APPLICATION FOR PERMIT TO DRILL						1. WELL NAME and NUMBER Moon 7-33-3-3W					
2. TYPE OF WORK DRILL NEW WELL <input checked="" type="checkbox"/> REENTER P&A WELL <input type="checkbox"/> DEEPEN WELL <input type="checkbox"/>						3. FIELD OR WILDCAT WILDCAT

**Newfield Production Company
Moon 7-33-3-3W
SW/NE Section 33, T3S, R3W
Duchesne County, UT**

Application for Permit to Drill Statement of Basis

Casing Schematic

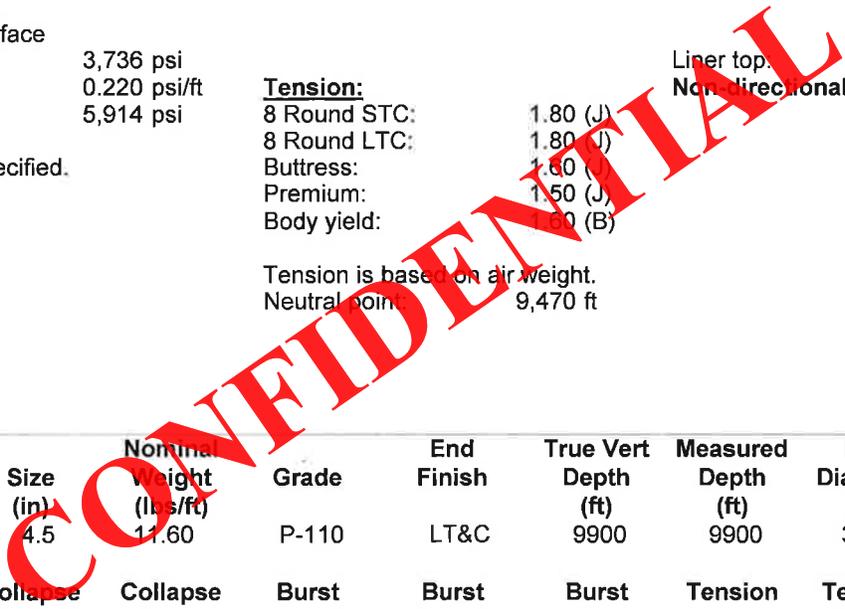
Units to surf @ 2% w/p, tail 429'
Prop. to surf.
**stop ✓*

✓ Stop amts.

30' Green River
TOC @ 778' @ 2% w/p tail
5676'
Proposed to 1000'
**stop ✓*

**OK ✓*

Cement volume for the 7" intermediate string shall be determined from actual hole diameter in order to place cement from the pipe setting depth back to 1000' MD as indicated in the submitted drilling plan.

Surface casing shall be cemented to the surface.
